# **Report on ad hoc call on Figure 154-3 and associated text**

IEEE P802.3ct Task Force, Interim Teleconference Call, 4 March 2021

Figure 154-3—DWDM black link example configuration for specifying  $n$  DWDM channels

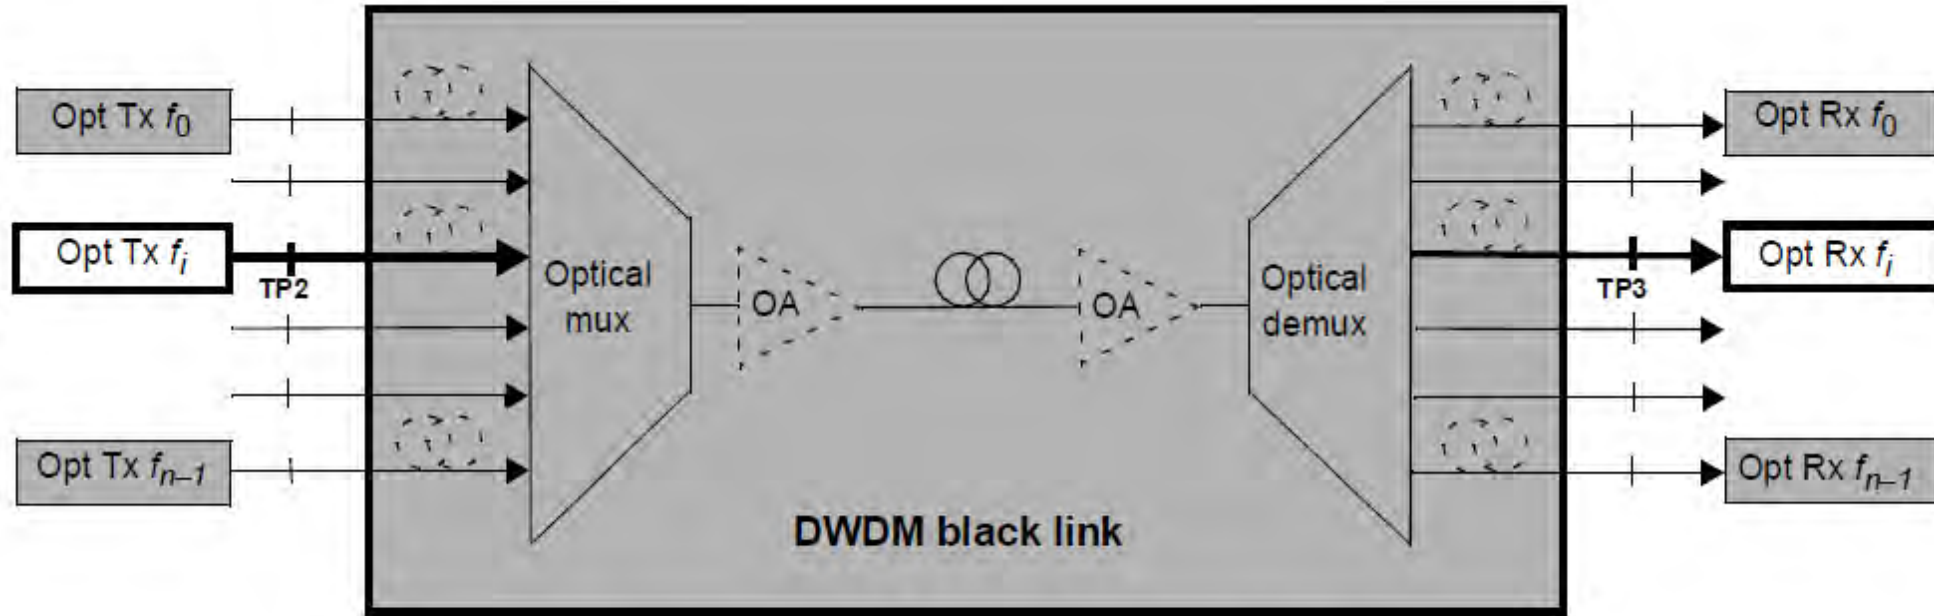
During the interim teleconference call on 18 February it was already agreed to take comment R1-2 as “lead” comment and refer to it for responses to comments R1-14, R1-29, R1-37, R1-53, and R1-54.

For the response to comment R1-2 the ad hoc proposes to label it as “accept in principle”.

Then adopt the consensus figure from slide 6 of [stassar\\_3ct\\_01a\\_210218](#) as a replacement for Figure 154-3 in draft D3.1. This figure is reproduced on slide 5 of this presentation.

It was the consensus of the ad hoc to modify Figure 154-3 to:

For clarity, only one direction of transmission is shown

For the relevant text in 154.6 and Figure 154-3 implement slides 5 and 6 of stassar\_3ct\_01a\_210304 (or updated if modified), with editorial license.

Figure 154A-1—DWDM black link example with one fiber per direction

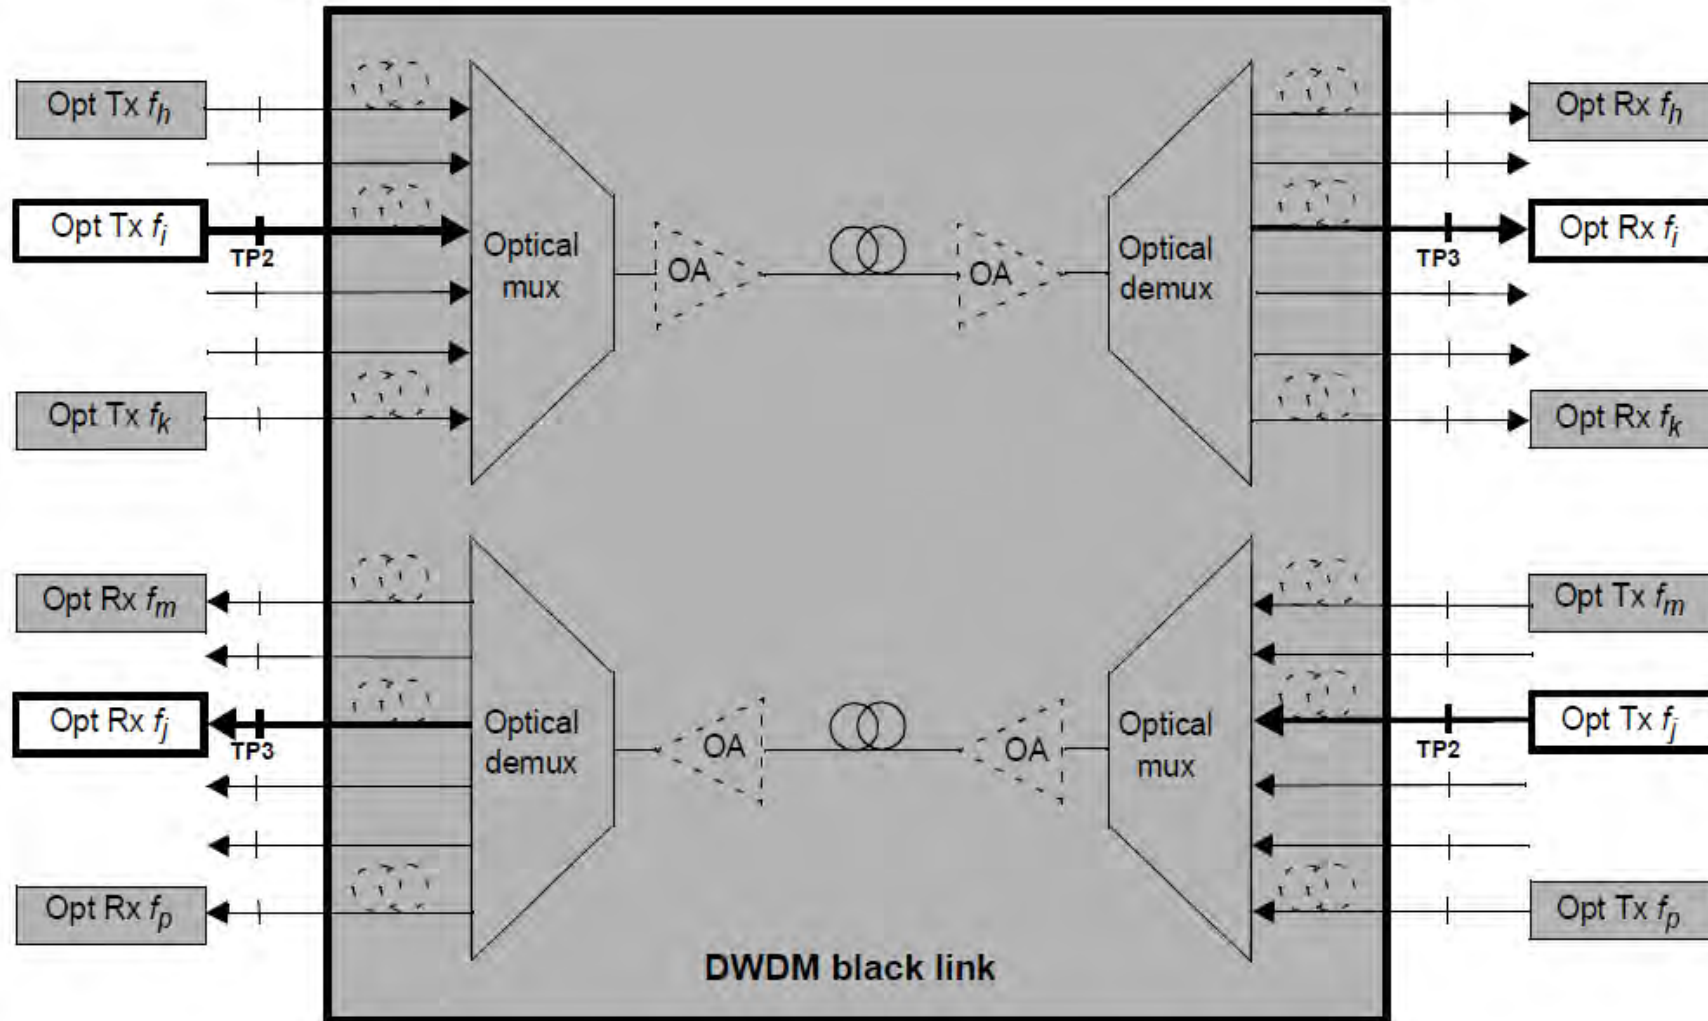
Further consensus was reached to create 2 new figures for inclusion in Annex 154A, shown on slides 7 and 8 and associated revised text for Annex 154A, shown on slide 9.

- Move the current text under “154A.1 Introduction” to a new subclause 154A.2 with heading “Relationship between OSNR and average optical power”.
- Renumber existing Figure 154A-1 to Figure 154A-3.
- Put the following text under “154A.1 Introduction”:

In implementations of the DWDM black link for 100GBASE-ZR, the channels supporting the full duplex links may be implemented on one fiber per direction, as illustrated in Figure 154A–1, or implemented on one fiber for both directions, as illustrated in Figure 154A–2.
- Renumber subclauses 154A.2 and 154A.3 to respectively 154A.3 and 154A.4.

For Annex 154A implement slides 7 to 9, with editorial license.
